# Waiohine FMP - Flood Modelling and Mapping Audit

Prepared for Greater Wellington Regional Council

Prepared by Beca Ltd (Beca)

9 May 2017

Figure 5.1 Development locations provided by Michael Hewison

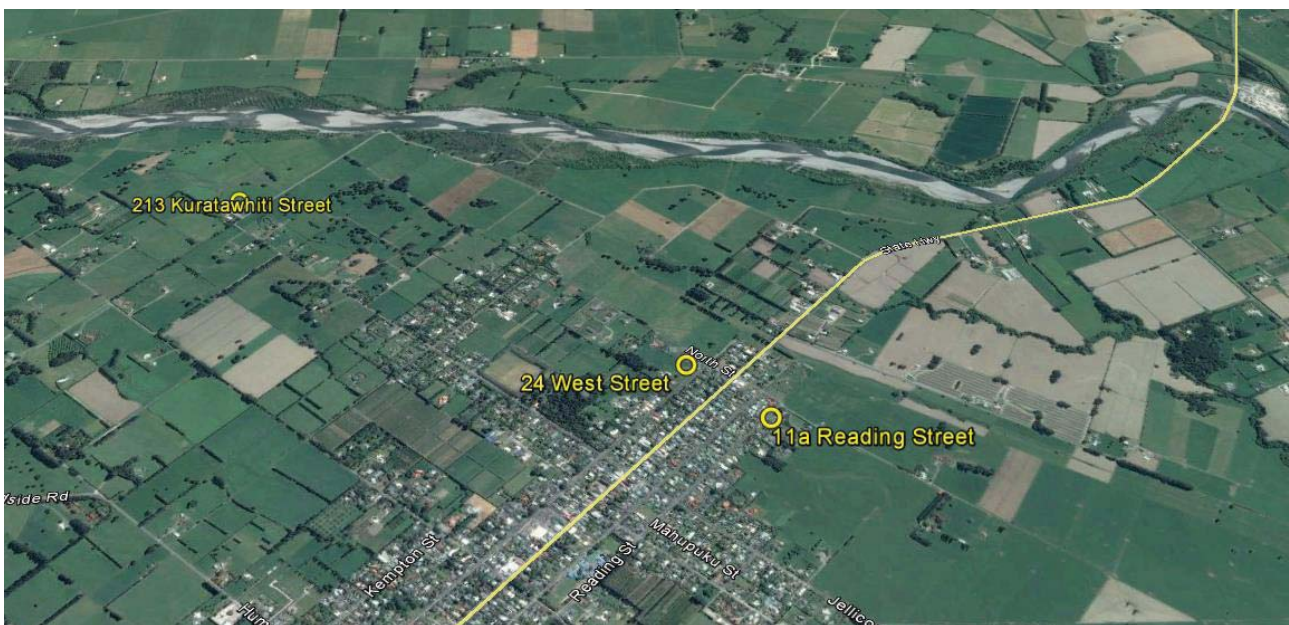
Of the issues raised above, one that is directly related to the 'modelling and mapping' terms of reference of the audit and has not been addressed in Section 4, is the issue of anomalies in flood information at the site-specific scale. Flood maps are limited by the quality of the information used to derive them. As has been noted above, the definition of flood depths and extents in Greytown is restricted by the grid spacing of the model bathymetry, which is 10 m. Michael Hewison provided Beca with examples of sites (Figure 5.1) where the flood information provided by GWRC apparently did not agree with his knowledge of the sites in question, or where the information was anomalous.

At the Kuratiwhiti Street and West Street properties, Michael Hewison noted similar sudden differences in flood depth and level that he could not reconcile with site contours, and at Kuratiwhiti Street also noted that while flood depth apparently altered significantly, there was no apparent change in water velocity.

Figure 5.2 Detailed flood map for 11a Reading Street, Greytown

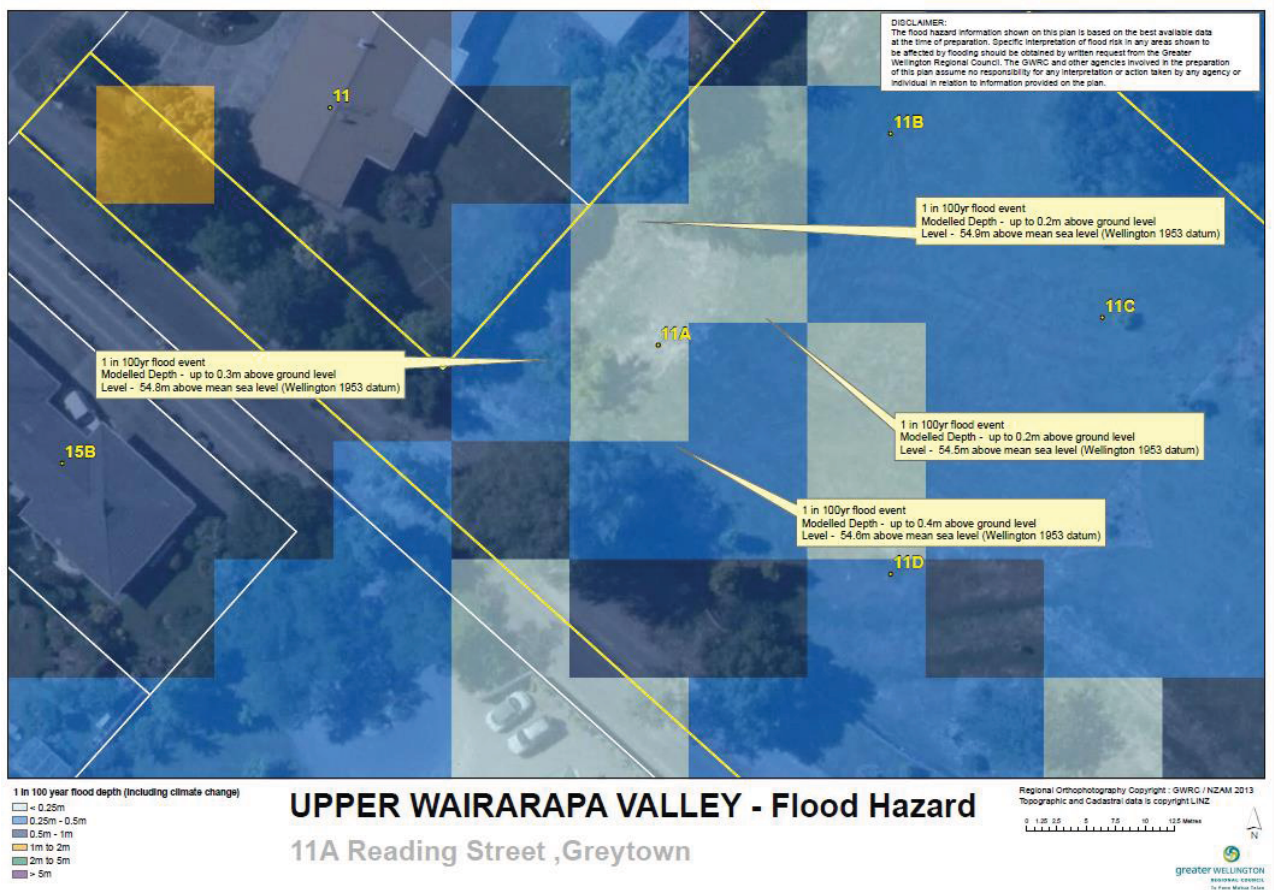
Figure 5.2 shows the detailed flood depth map for 11a Reading Street with annotation by Michael Hewison. Due to the pixilation caused by the 10 m model grid and the flood depth layers used in the map legend, it is possible to imply a 400 mm difference in water level across a relatively flat section and a distance of 10-20 m, but that does not necessarily reflect a true interpretation of the information.

As part of the audit, these apparent anomalies have not been investigated in detail, but they represent the difficulties of translating flood modelling undertaken with a relatively large grid size to mapped outputs at the site-specific scale. A 10 m grid means that the area of each grid cell is 100 m<sup>2</sup>, approximately half the size of the medium-large house footprint, and only six to ten grid cells would cover most suburban residential sections. Ground levels can vary significantly within one grid cell, especially if it contains drainage channels, road edges or crowns, or property boundaries, and flood levels across a property may reflect flooding from more than one source or flow path.

Within the MIKE software, one ground level is applied to the whole grid cell, which loses the underlying definition of the ground surface, and results in the pixelated flood maps, such as shown in Figure 5.2. A way round this problem is to use a smaller model grid size (or flexible mesh) to improve definition, though this will have an impact on model run times.

Alternatively, post-modelling process of map outlines can be carried out to smooth flood outlines, remove isolated anomalous cells, and ground truth the results. This is an approach being used in Hamilton and incorporated into Hamilton City Council's update stormwater modelling guidelines. However, post-modelling intervention does bring a subjective element into the mapping process, which could be open to dispute.

Some 2D flood modelling packages (such as HEC-RAS) retain the ground surface detail even if the grid spacing is relatively large, and use that detail when preparing the flood outlines. This smooths the outlines, thereby removing pixilation and the risk of anomalous interpretation of the flood information.
